INNER WEST				
DEVELOPMENT ASSESSMENT REPORT				
Application No.	MOD/2022/0474			
Address	93 Louisa Road BIRCHGROVE			
Proposal	Modification to development consent D/2018/25 including (but not limited to) changes to building footprint, windows, internal layout, balcony/deck/roof terrace, screening, balustrades, fenestration, lift overrun; materials, colours and finishes also amended.			
Date of Lodgement	23 December 2022			
Applicant	Mr Franco Bilotta			
Owner	Mr Franco Bilotta & Mrs Barbara Bilotta			
Number of Submissions	Initial: 2			
Value of works	\$1,464,000.00			
Reason for determination at Planning Panel	Departure to FSR development standard exceeds 10%			
Main Issues	<ul style="list-style-type: none"> - Non-compliance with FSR - Substantially the same development (Section 4.55) - Visual privacy - Unauthorised works - Heritage 			
Recommendation	Approved with Conditions			
Attachment A	Recommended conditions of consent

This report provides an assessment of the application to modify consent D/2018/25 dated 12 June 2018 under s4.55(2) of the Environmental Planning and Assessment Act 1979 at 93 Louisa Road Birchgrove.

Figure 3 - View Analysis Plan (ESNH Design Pty LTD, October 2022)

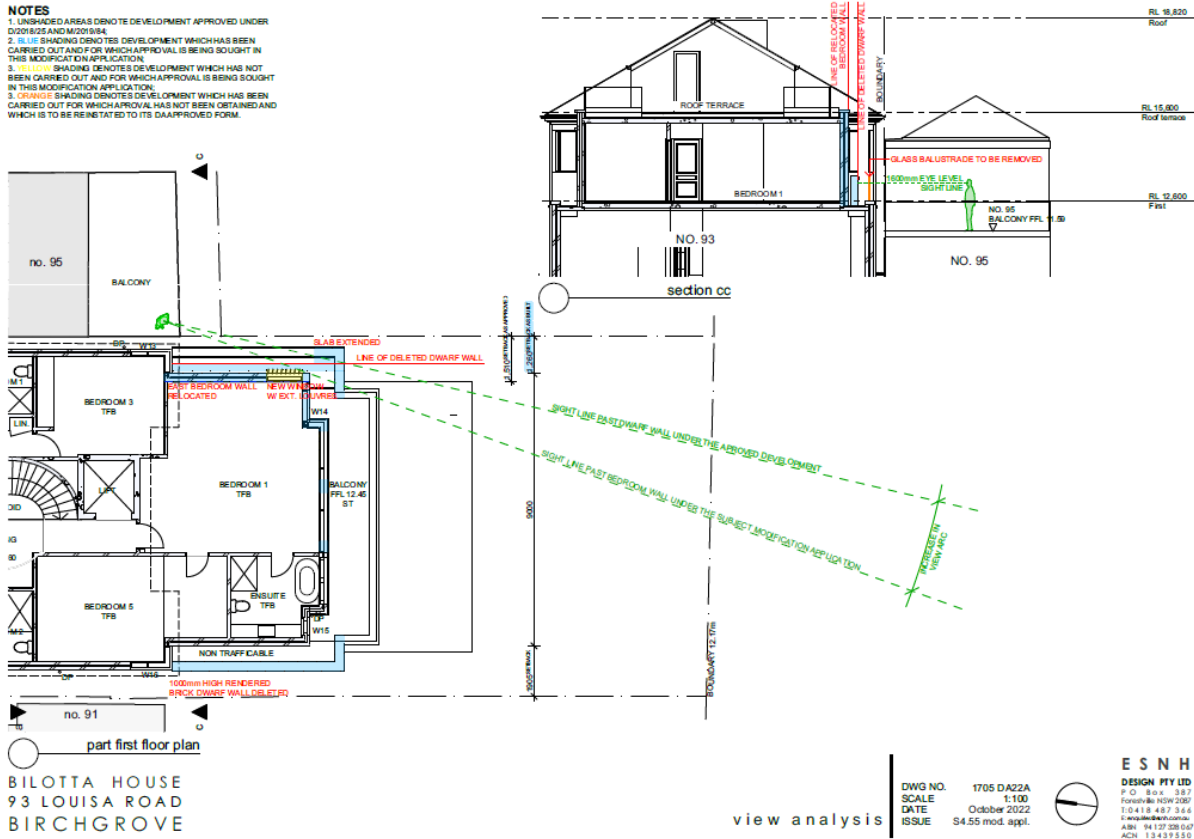
In order to address potential view impacts for the neighbouring property at 95 Louisa Road, a View Analysis Plan has been prepared by ESNH Design Pty Ltd. The First Floor Plan shown in the View Analysis Plan shows a comparison of sight lines between the existing approved development as modified (which includes a dwarf wall) and that proposed under this modification (beyond the bedroom wall, with the approved dwarf wall deleted).

The reduction in height of masonry walls from 860mm to 230mm and the introduction of frameless glass balustrading above the masonry walls at the roof terrace will maintain reasonable view sharing achieved from 91 Louisa Road.

This Application will provide a greater view range for the occupants of 95 Louisa Road than the existing approved development as modified and is considered to appropriately address the potential view loss impacts for the neighbouring property.

Figure 5 - View from first floor balcony to the east (Photo supplied)

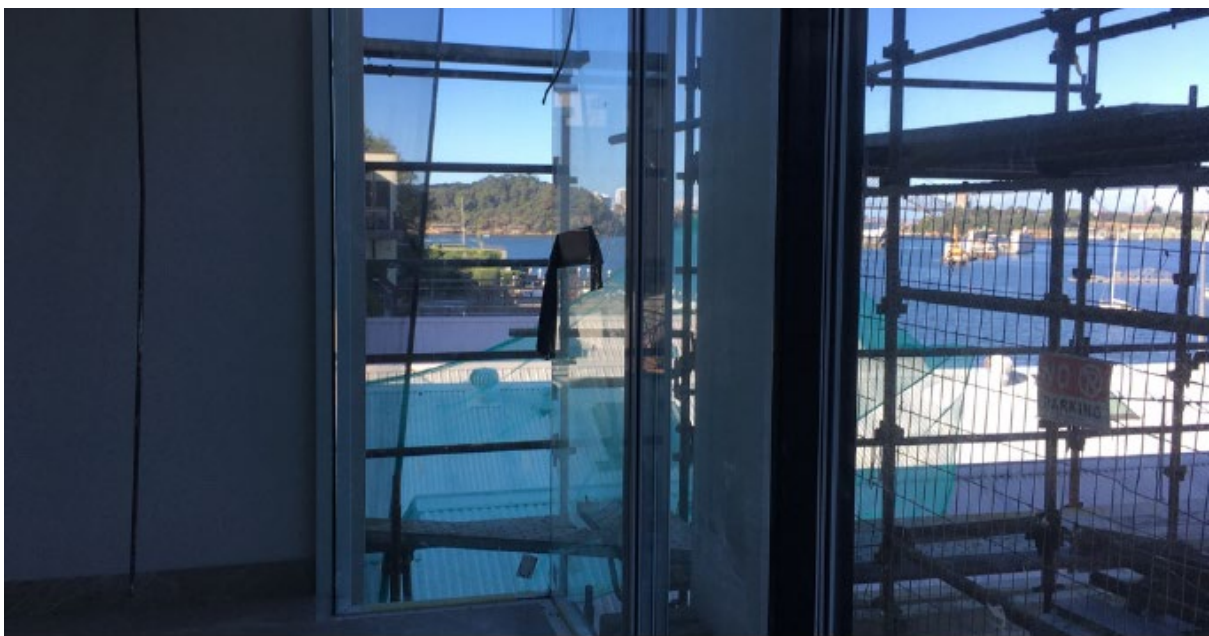
Furthermore, the view analysis View Analysis plan been prepared by ESNH Design Pty Ltd demonstrates that no adverse visual privacy impacts arise as a result of the matters covered by this Application (Figures 4 and 5).

Therefore, the proposed modifications are not considered to reduce privacy to neighbouring properties.

upper ground floor plan

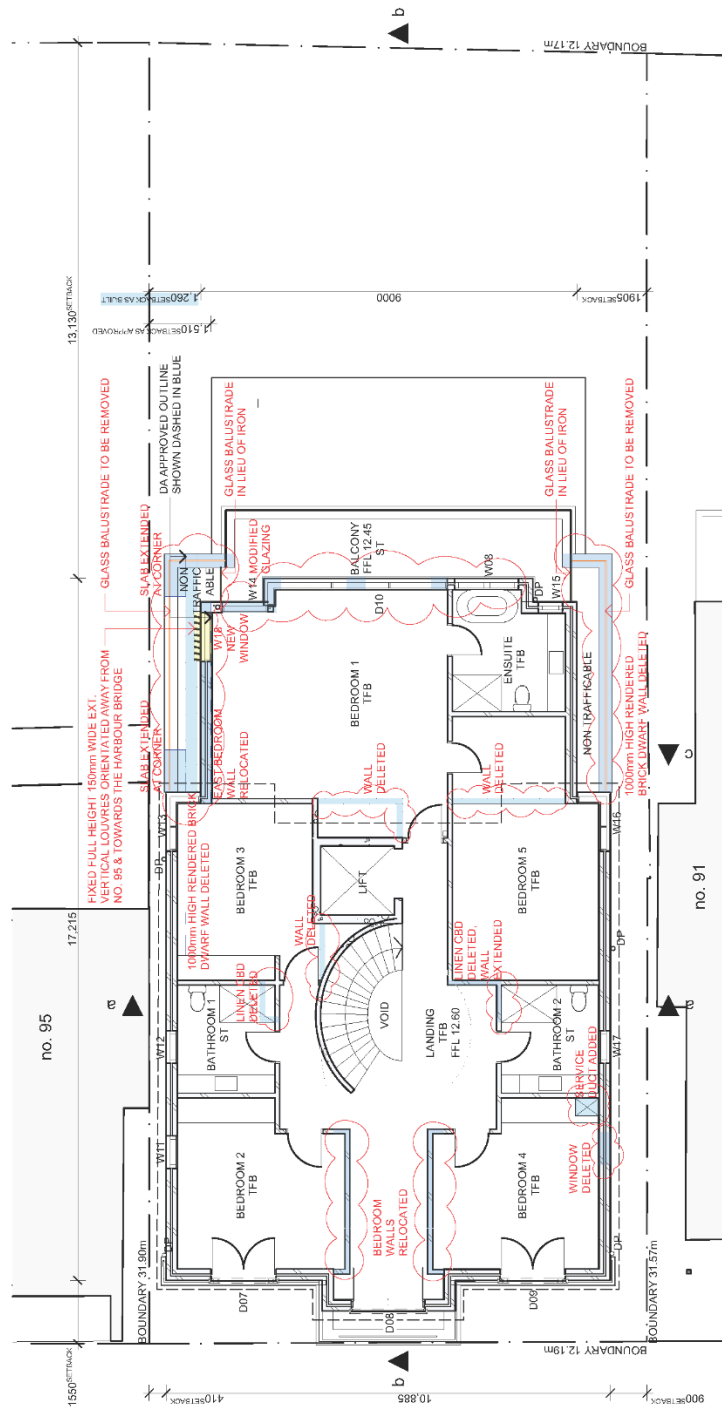
The proposed modifications to the upper ground floor do not reflect the internal roller door that was observed during the site inspection. The plans need to reflect that roller door or the deletion of that roller door must be confirmed.

Comment: Plans amended to reflect the upper floor roller door.
